# Sun StorEdge network FC switch-8 and switch-16 Release Notes

Part No. 806-6924-14  
February 2001, [Revision A](#)

**FIGURE 1** Example: Single Host Connected to Multiple StorEdge T3 Partner Pairs, Using Switches

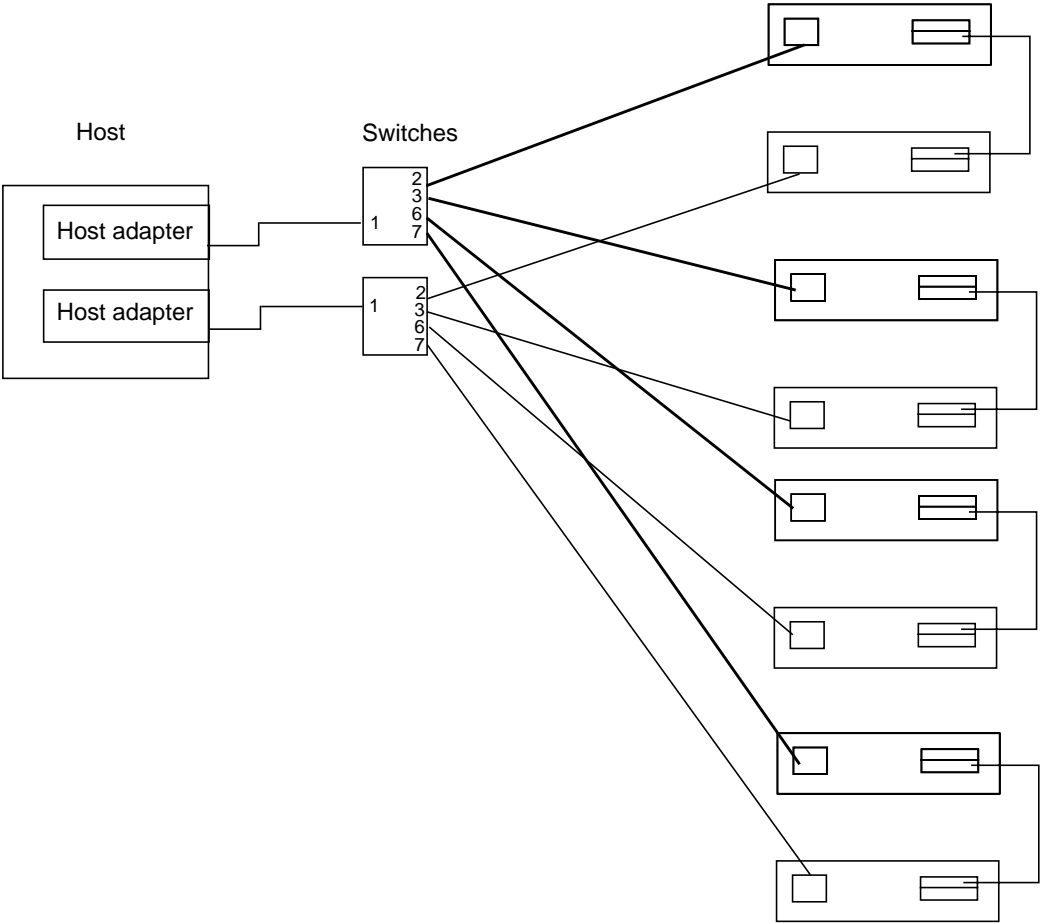
## T3 Single Host Connections to the Switch

Figure 2-6 shows a single host connected to multiple StorEdge T3 partner pairs. The correct port assignments for this configuration follow. See FIGURE 1.

When used with a switch, the T3 supports a maximum of two initiators per zone for a single T3 brick (one per LUN), and a maximum of one initiator for a T3 partner pair.

**FIGURE 2** Example: Two Hosts Connected to Four StorEdge T3 Partner Pairs, Using Switches

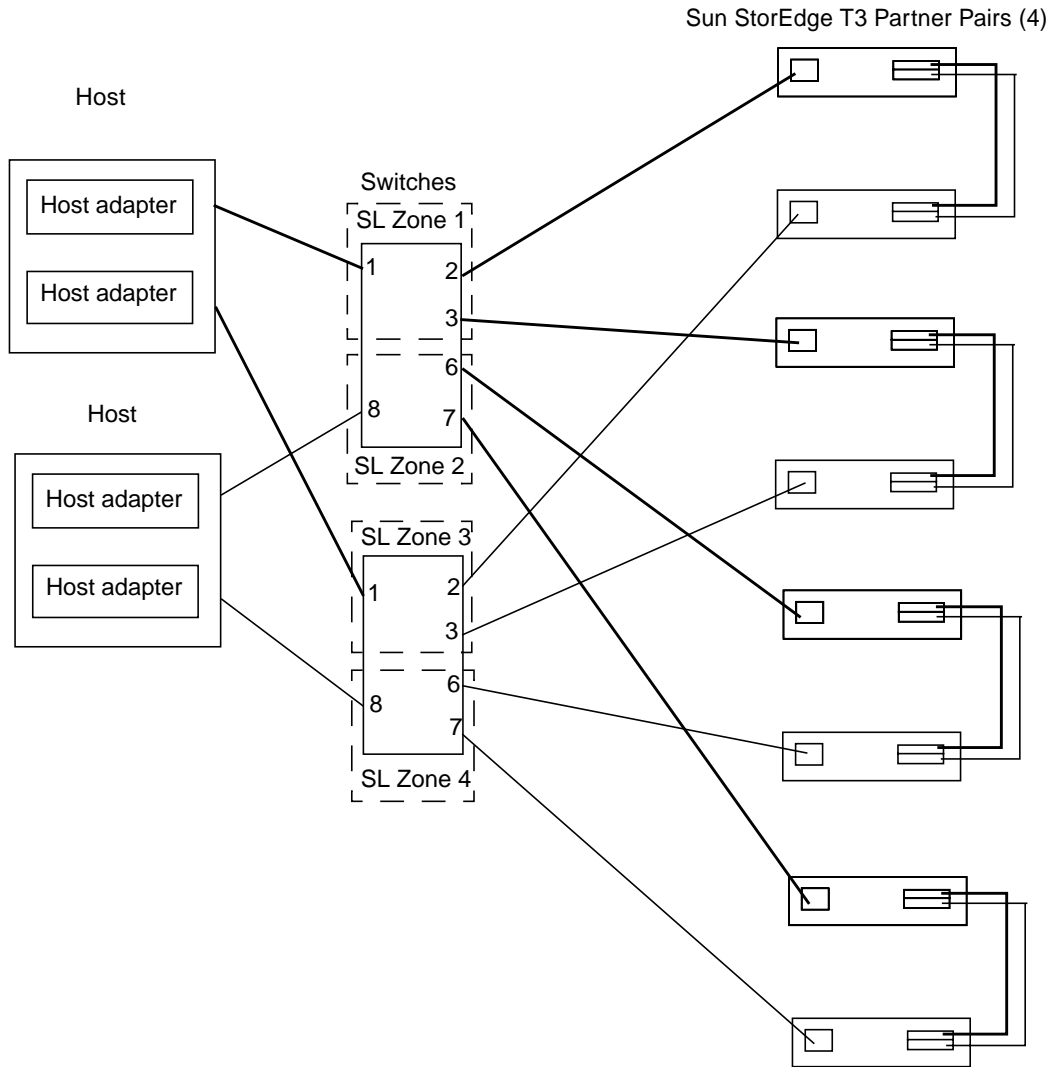
Figure 2-9 of the Installation and Configuration Guide shows a configuration of two hosts connected to four StorEdge T3 partner pairs. Figure 2-9 is incorrect. When multiple hosts are connected to T3s, zoning is needed to ensure that the maximum number of initiators for a T3 partner pair is one per zone. For non partner-pair T3 configurations, one initiator per LUN is allowed, which results in a maximum of two initiators per zone. See FIGURE 2 for the configuration restrictions.
